24 May 2022

Our ref: 331201108pbond001.Docx

**Re: Proposed extraction of sand and gravel at Hamble Airfield: response to consultee queries**

Figure 1 Superficial deposit hydrographs – depth below ground level

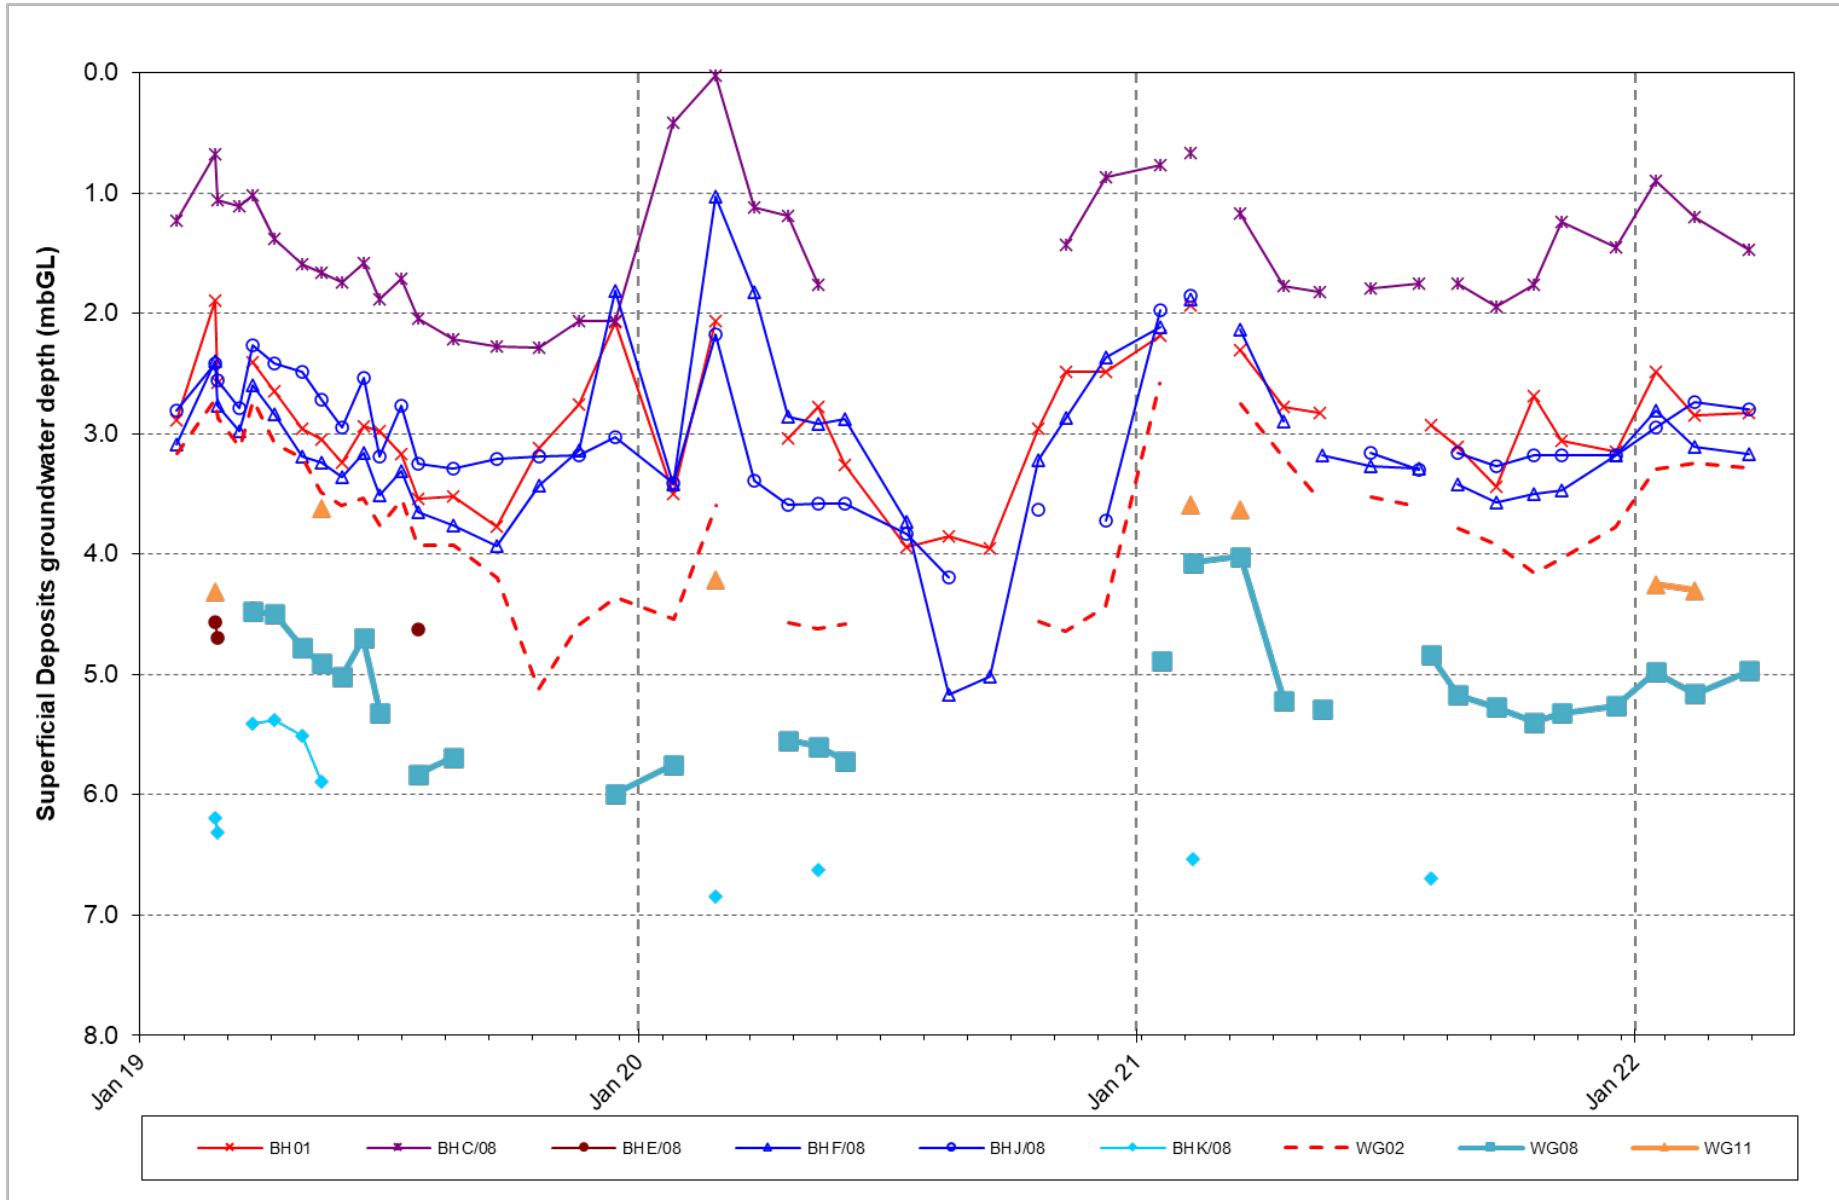
With respect to groundwater depths, there are three cross sections presented in Chapter 8 of the Environmental Statement. Of the seven locations presented that have groundwater level data, only one shows the *maximum* water level within 1m of the ground surface. This is BHC/08 and it shows the shallowest groundwater levels at the Site, as shown on Figure 8.15 of Volume 2, Chapter 8 of the planning application.

We have plotted the hydrographs to the current time in Figure 1 (superficial deposits) and Figure 2 (solid strata). This shows that it is only the pair BHC/08 and W03 which are located in the northeastern extent of the Site that occasionally rise above 1 m below ground level (see Figure 8.14 in Volume 2, Chapter 8 of the planning application for locations). In this area, infiltration is less likely to occur in the wettest periods. However, around the rest of the perimeter there is sufficient unsaturated zone for infiltration to occur at all times of the year. Drainage calculations have demonstrated that the overall site discharge will not exceed that of the greenfield runoff rate, as per CIRIA guidance.

We also note that there is relatively little groundwater present within the superficial deposits and the gaps in the hydrographs indicate that the wells are frequently dry.
